Ref:	NR/L2/ELP/27009/MOD C26
Issue:	1
Date:	03/12/2011
Compliance date:	03/03/2012
Page	1 of 4

OVERHEAD LINE CAMPAIGN CHANGES – DATA SHEET	
26	BURNING AT "TEE OFF" BI-METAL TERMINATION FEEDER CONNECTIONS
COMPONENT	Bi-metallic 'tee' connections to copper return conductor or feeder wires, using bi-metallic lug attached to parallel groove 'elephant' clamp (see drawing 1/997/498).
PROBLEM	<p>The elephant clamp will overheat and loosen over time, because the nickel gunmetal outer pieces of the clamp are not electrically rated for traction current. This will lead to arcing and eventual failure of the conductor.</p> 
Reference Information	
Ellipse standard job number	13026
Ellipse standard job description	Upgrade feeder bi-metal "T Off" terminal
Category	Feeder
Priority	Yes
Types of OLE affected	Ex-DC; Mk 1
Original equipment dates	1982

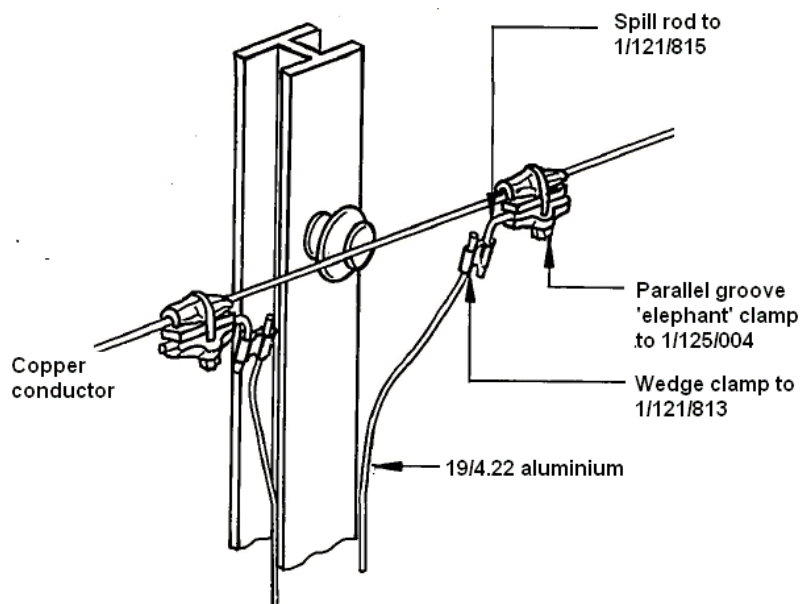
ACTION REQUIRED

Replace connections as follows:

1. If possible, minimise use of bi-metal connections either by extending copper conductors or by replacing copper conductors with aluminium.
2. Replace connection with alternative using bi-metallic spill rod (OLEMI drawing 121/815) and wedge clamp (drawing 121/813) as follows. This does not rely on passing current through the outer pieces of the clamp.

Note that the parallel groove 'elephant' clamp shown in this sketch no longer uses a U-bolt.
